UNITED STATES  
NUCLEAR REGULATORY COMMISSION  
WASHINGTON, D. C. 20555

SUBJECT: SEP SAFETY TOPICS III-6, SEISMIC DESIGN CONSIDERATION AND  
III-11, COMPONENT INTEGRITY - GINNA NUCLEAR POWER PLANT

SEP SAFETY TOPIC EVALUATION

TOPICS: III-6, SEISMIC DESIGN CONSIDERATION  
III-11, COMPONENT INTEGRITY

FIGURE 1

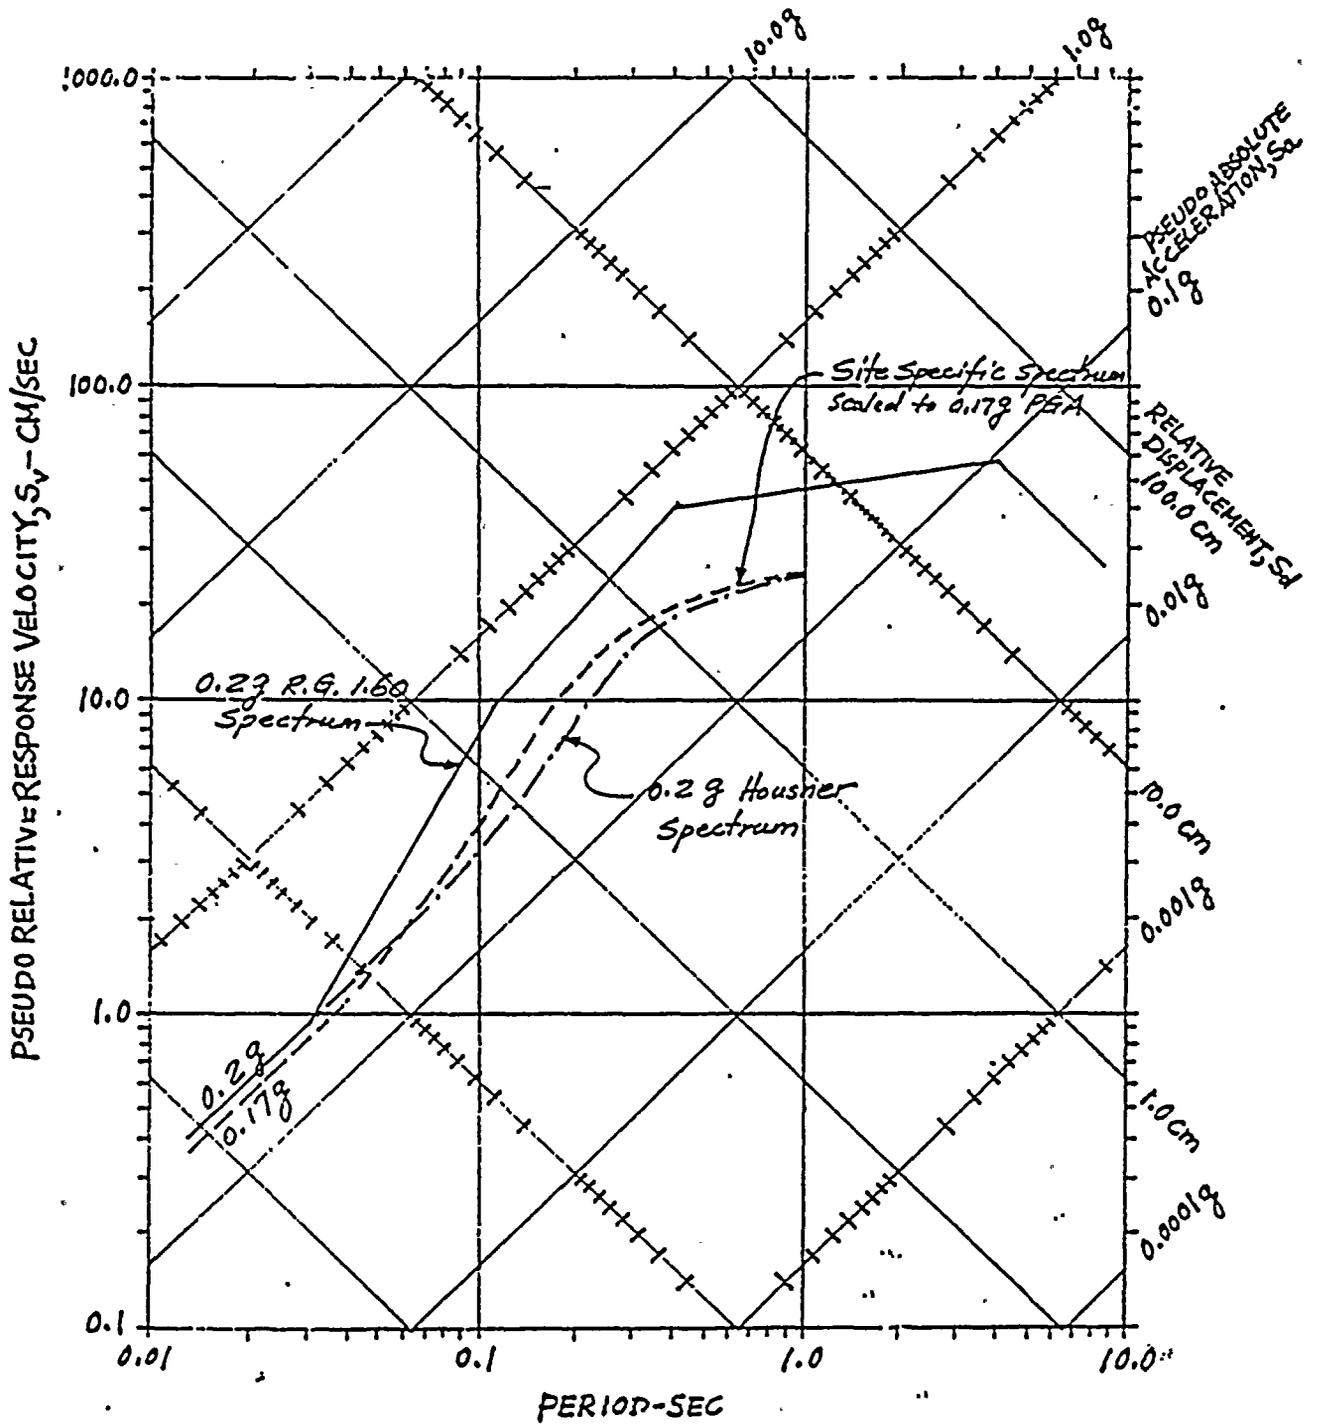
The related SEP topics to the review of Seismic design considerations and component integrity are II-4, II-4.A, II-4.B, and II-4.C. These topics relate to specification of seismic hazard at the site, i.e. site specific ground response spectrum for the Ginna site. The seismic input selected for the confirmatory analysis of Ginna facility, namely the Regulatory Guide 1.60 spectrum scaled to 0.2g peak ground acceleration, envelopes the Ginna site specific ground response

as shown in Fig. 1, therefore the results for these four safety topic evaluation will not affect the review of seismic design considerations and component integrity.
